Access Compliance Report

Public Rights-of-Way

Intersection ID: 28763	Main Street: CAMBRIDGE COMMONS DR	Cross Street: GREATFORD CT	Location: NW
ADA ID: 9F5116FFDD4D	Ramp Type: BlendTrans1	Initial Pass/Fail: Fail	Overall Compliance: No
		Severity Score: 10

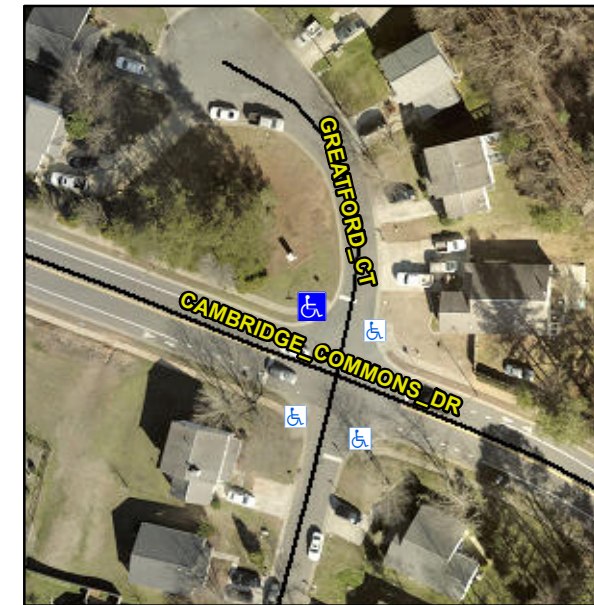
NO RT SW

R304.5.1, R304.5.3

Remove & Replace Curb Ramp With Two New Directional Ramps or Equivalent.
